UNITED STATES
DEPARTMENT OF THE INTERIOR
BUREAU OF LAND MANAGEMENT

FORM APPROVED
OMB NO. 1004-0137
Expires: January 31, 2018**SUNDRY NOTICES AND REPORTS ON WELLS**
*Do not use this form for proposals to drill or to re-enter an abandoned well. Use form 3160-3 (APD) for such proposals.*5. Lease Serial No.
NMNM33437A

☒ Oil Well ☐ Gas Well ☐ Other8. Well Name and No.
ROCHE FEDERAL 4

** BLM REVISED ** BLM REVISED ** BLM REVISED ** BLM REVISED ** BLM REVISED **

CURRENT WELLBORE

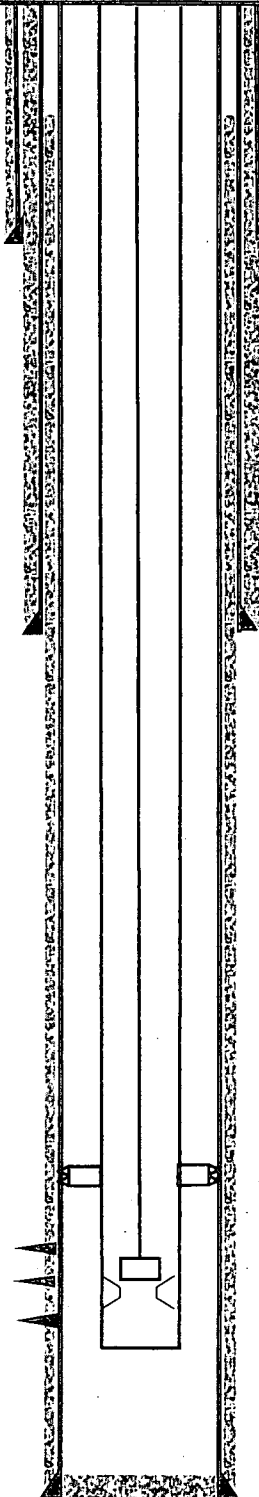
<i>Yats</i>	<i>1845</i>
<i>TR</i>	<i>2300</i>
<i>Qu</i>	<i>2982</i>
<i>CB</i>	<i>3459</i>
<i>SA</i>	<i>4158</i>
<i>BS</i>	<i>4956</i>

PROPOSED WELLBORE

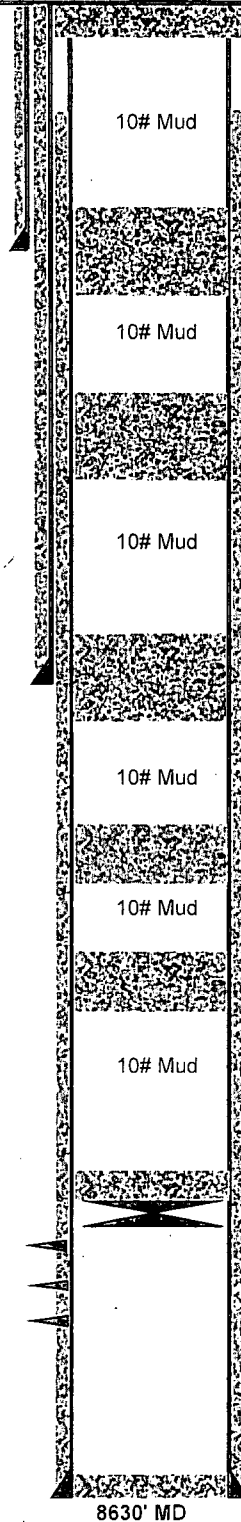
1. Perf @ 140'.
2. Squeeze CI C from 140' to surface.
3. Cut WH off 3' BGL, set dry hole marker.

Spot 25 sx CI C from 750'-500'. WOC & tag.
(Shoe @ 650')

Spot 25 sx CI C from 1930'-1680'. WOC & tag.
(Top Yates @ 1880')

Spot 25 sx CI C from 2550'-2300'. WOC & tag.
(Shoe @ 2484')

Spot 25 sx CI C from 4300'-4050'.
(Top Delaware @ 4300')

Spot 25 sx CI C from 5325'-5075'.
(Top Bone Spring @ 5315')

1. Set CIBP @ 8300'. Tag. Circ 10# salt gel.
2. Spot 25 sx CI H from 8300'-8100'.
(Perfs at @ 8340')

GC 6/25/19
Accepted for record - NMOCDSEE ATTACHED FOR
CONDITIONS OF APPROVAL*Below ground level dry hole marker required*
